Legends Resort & Casino

Bid Package 1 – Envelope

Addendum No. 02

Date: July 7, 2023

Appendix A
{*Ref. ADD02 Narrative RFI #04}
Preliminary Documents are for Reference Only
(*Not Part of 95% Issued Documents Set)

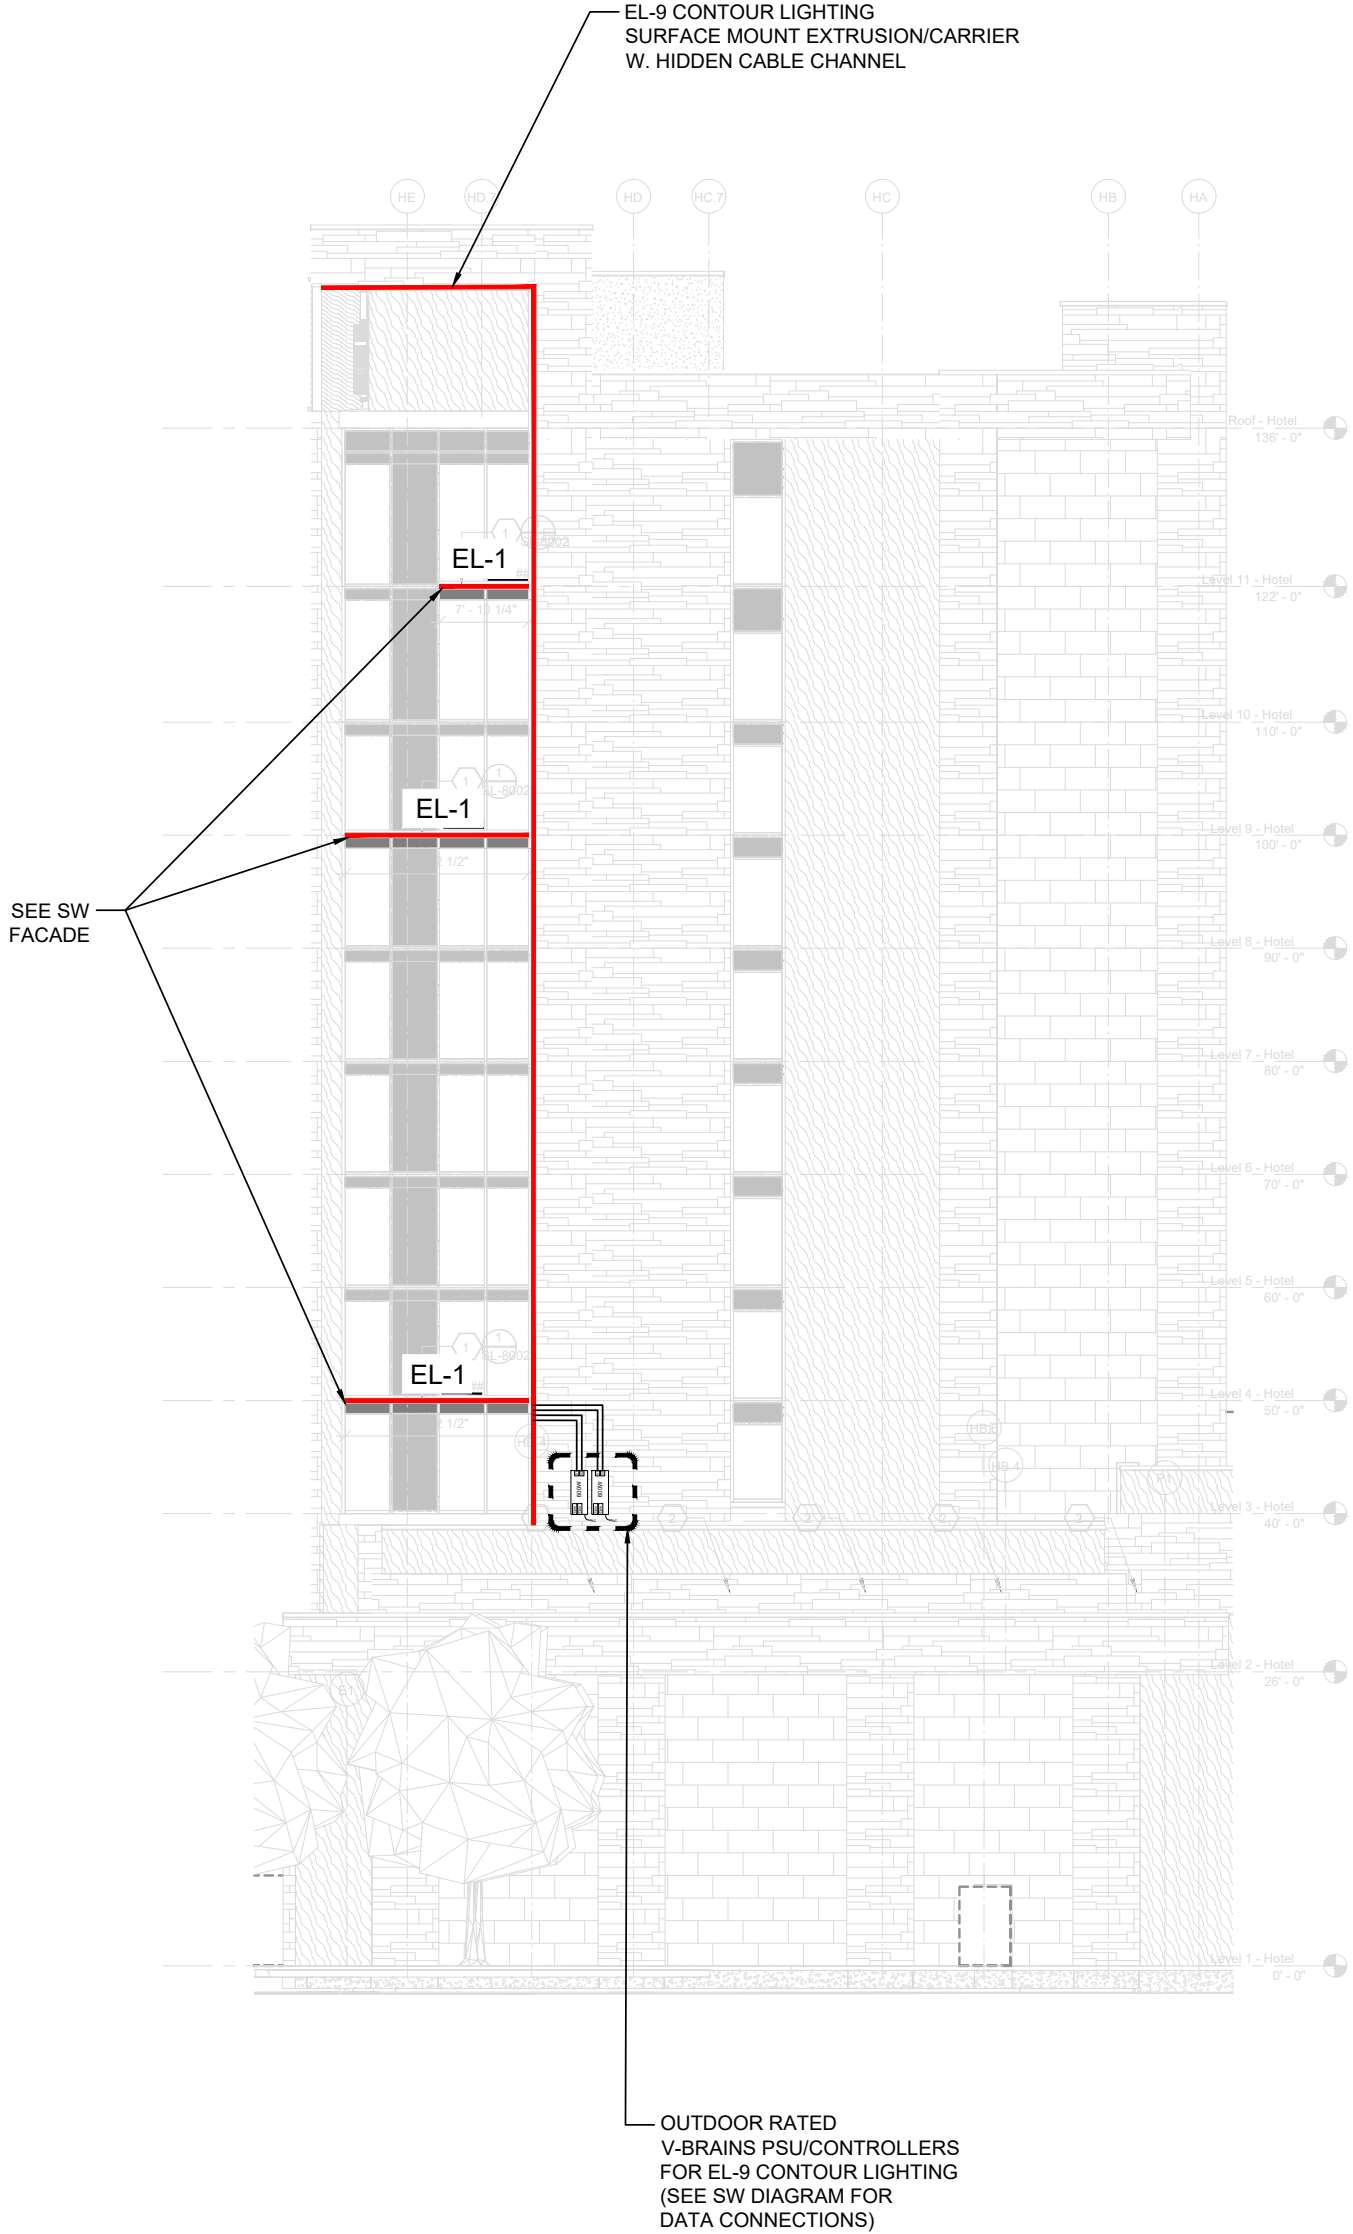
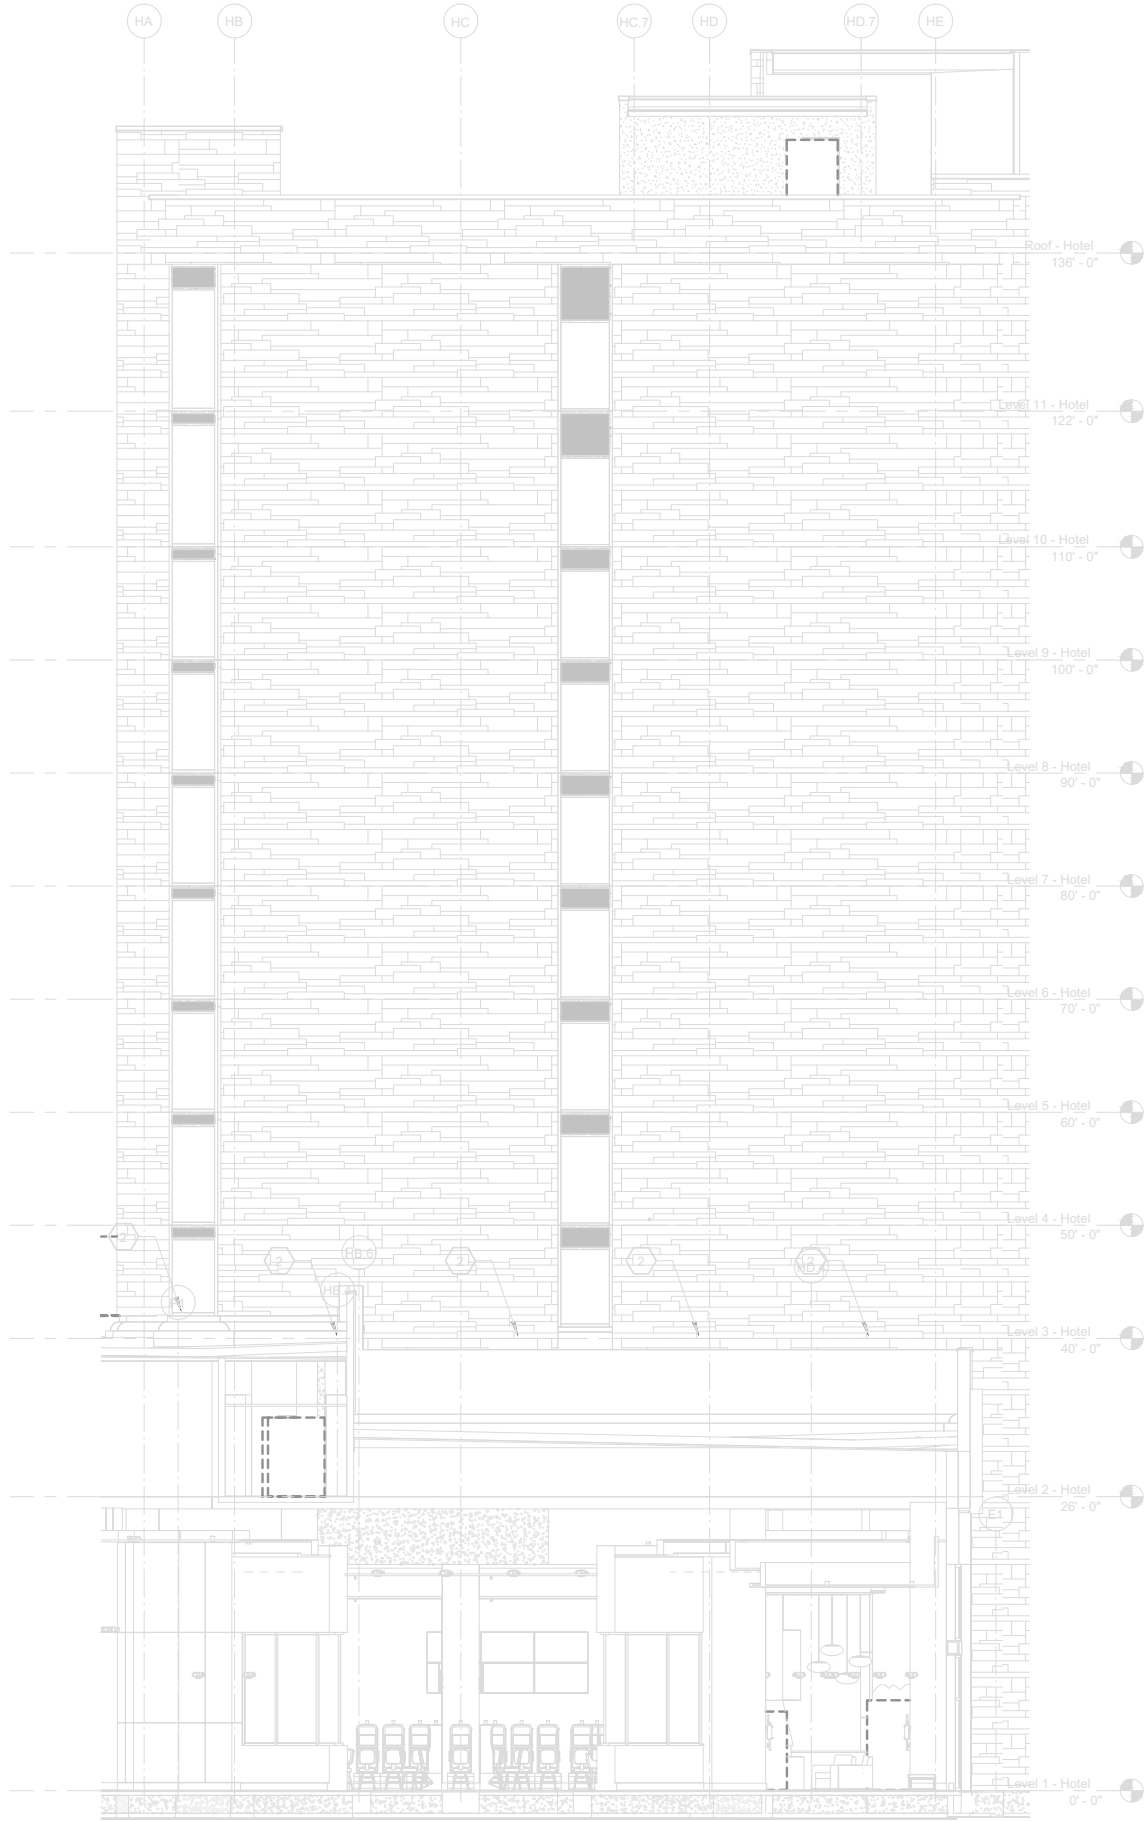
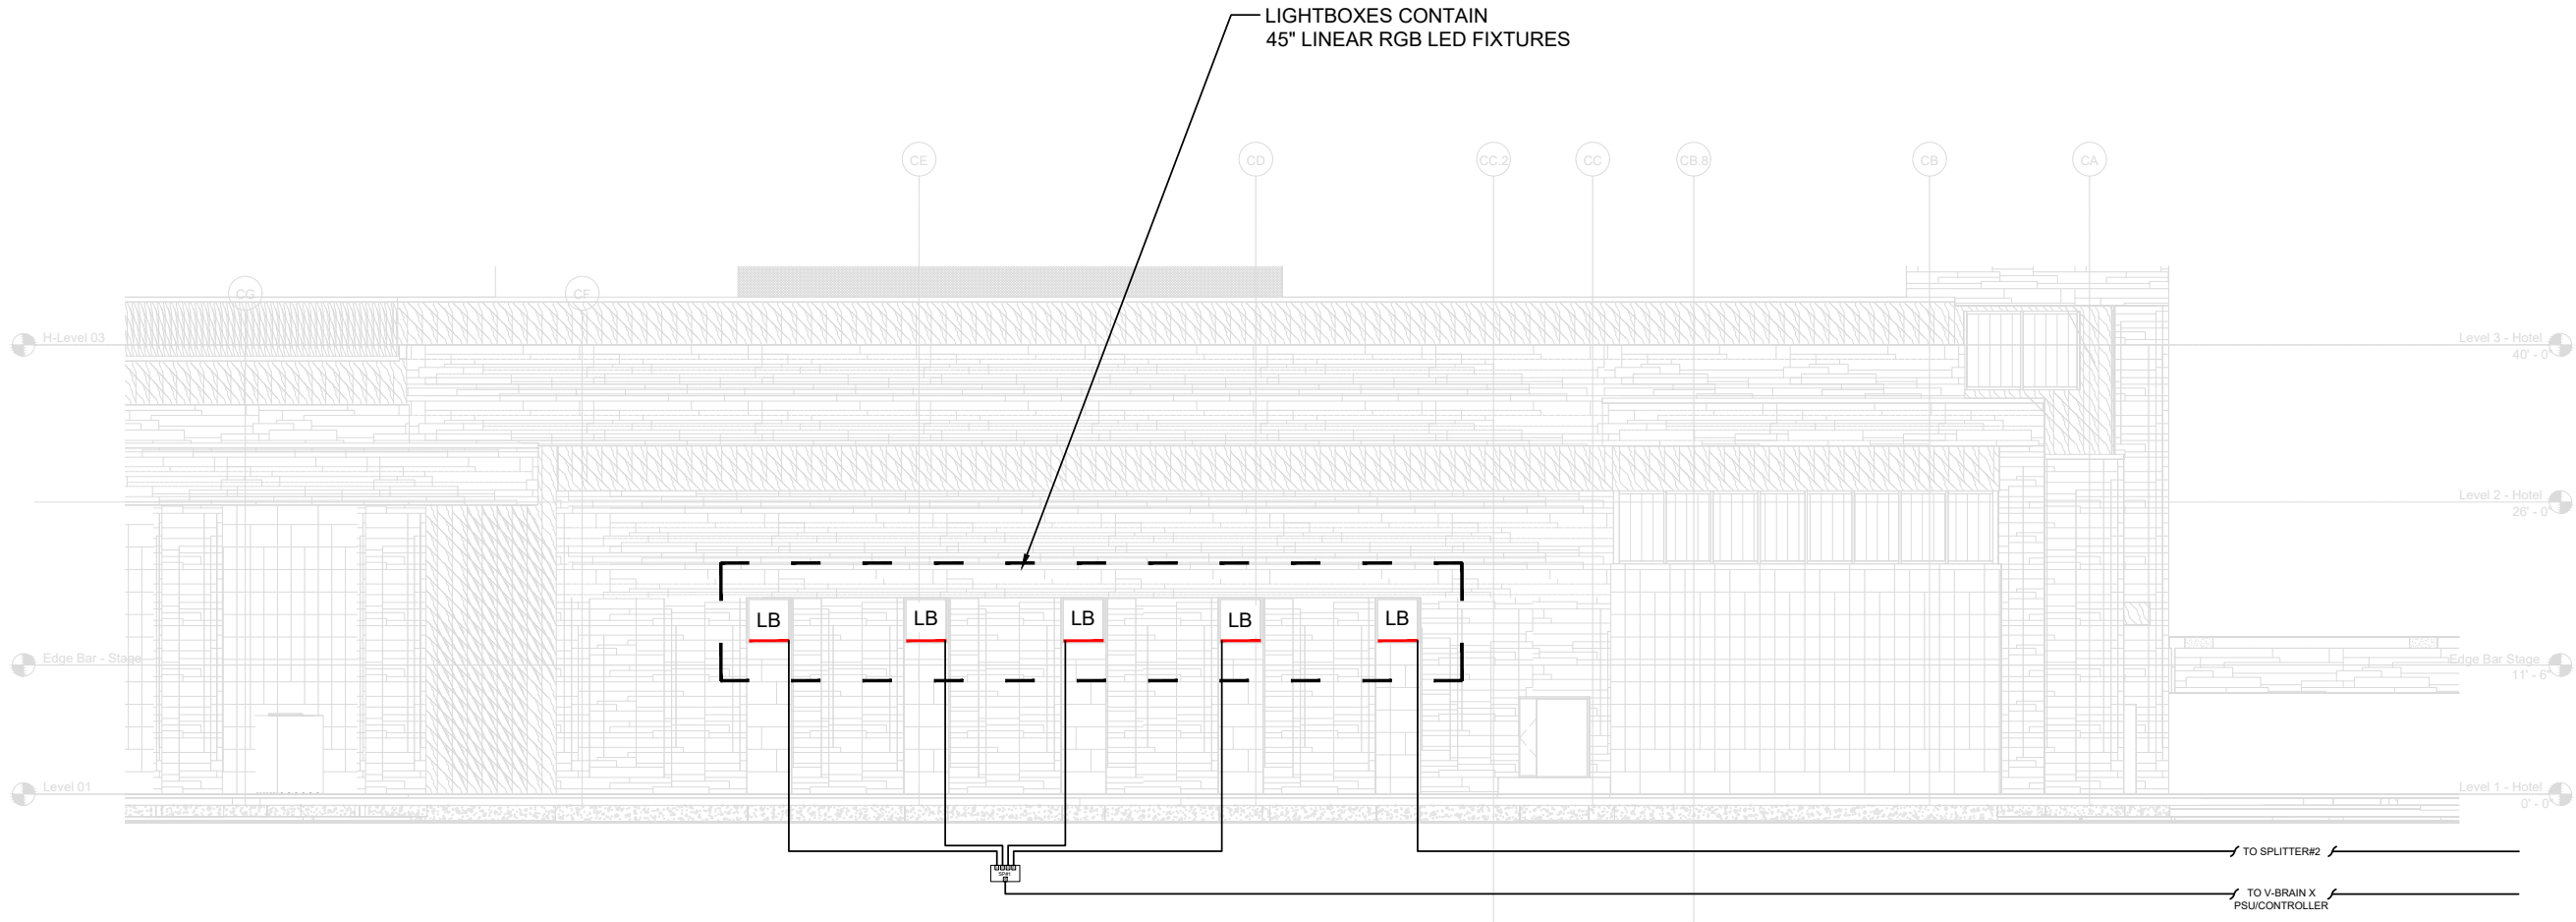
- 04) [Question] Unitized curtain wall system includes mullion mounted exterior strip lighting. Contractor required coordination for this work. We will need additional information regarding the mullion mounted exterior strip lighting so we can confirm attachment to the curtain wall. Also, please confirm that the exterior strip lighting will be by others and that curtain wall contractor will only need to coordinate this work. {This includes all embeds and anchorage.} Please confirm if it's CDI's intent to have the curtain wall contractor supply the embeds for the project.
[Answer] This question is with the design team and response is pending. See the product data attached to this Addendum 02 Q/A narrative sheet labeled as "Appendix A" for the proposed exterior hotel tower strip lighting system for your reference. The proposed manufacturer is SACO's V-Stick lighting system that is to be furnished and installed by the electrical/specialty lighting contractor including mounting accessories to

the curtain wall system. Exterior curtain wall contractor's responsibility is to coordinate with CDI Contractors, the electrical contractor, and the lighting manufacturer prior to final submittal approval and start of curtain wall production. Please assume that the curtain wall contractor will need to include incorporation of a seamless strip lighting design within the curtain wall system.
